## HILL VALLEY - PHASE 2B

CITY PROJECT NO. 15860  
CONTRACT NO. 9680

#### REVISION 1 - 04/29/26

#### REVISION 2 - 05/28/26

LANDSCAPING PLAN - ENCHANTMENT ROAD  
 HILL VALLEY - PHASE 2B  
 M:\DESIGN\Projects\15860\CAD\Streets\15860EN-LandscapingPlan.dwg

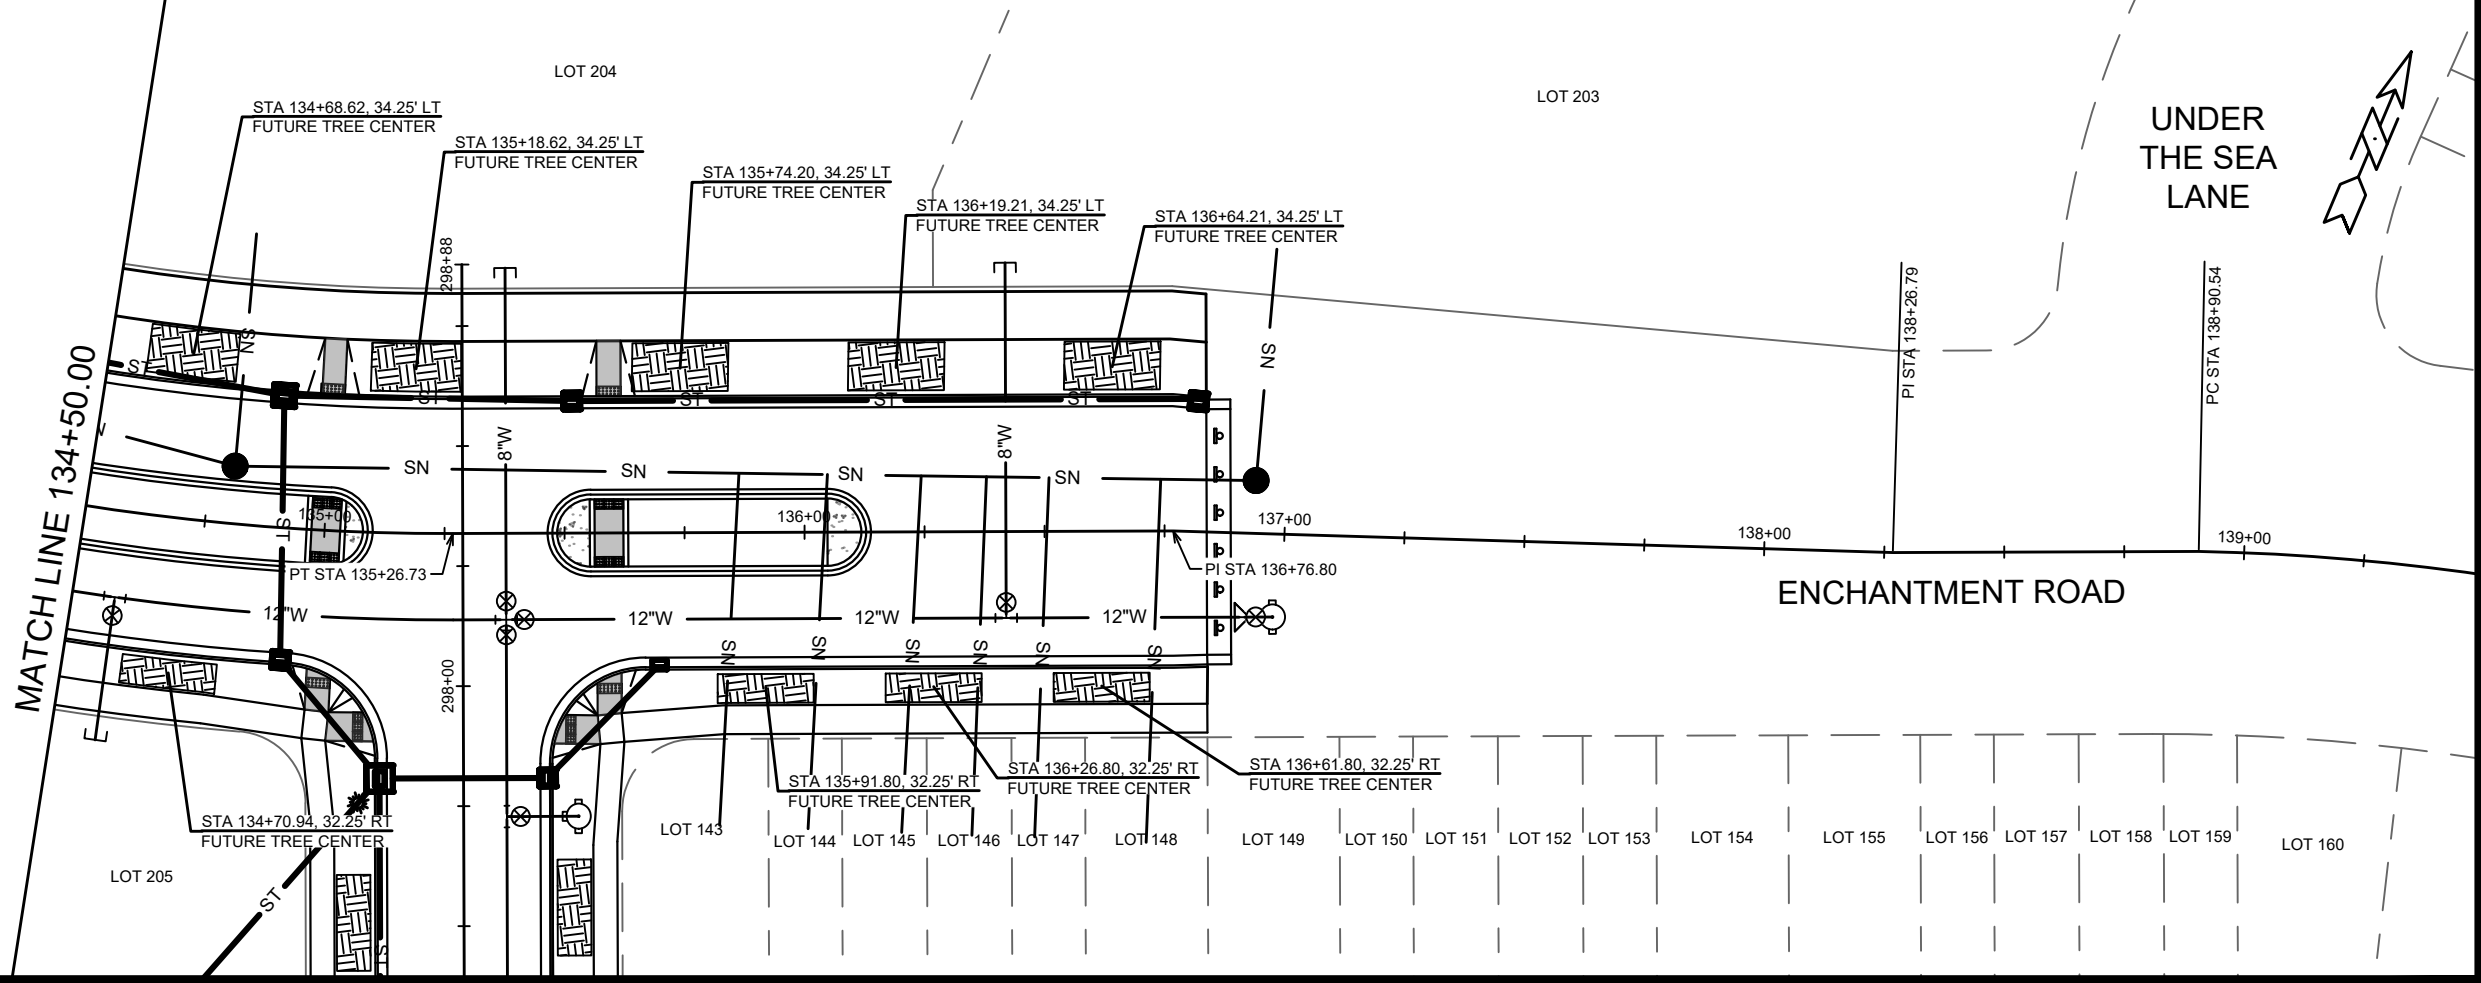
**REVISION 2 - GCIT - 05/28/26**  
 - PLANTING SITE RELOCATION  
 - UPDATED UTILITIES LAYOUT
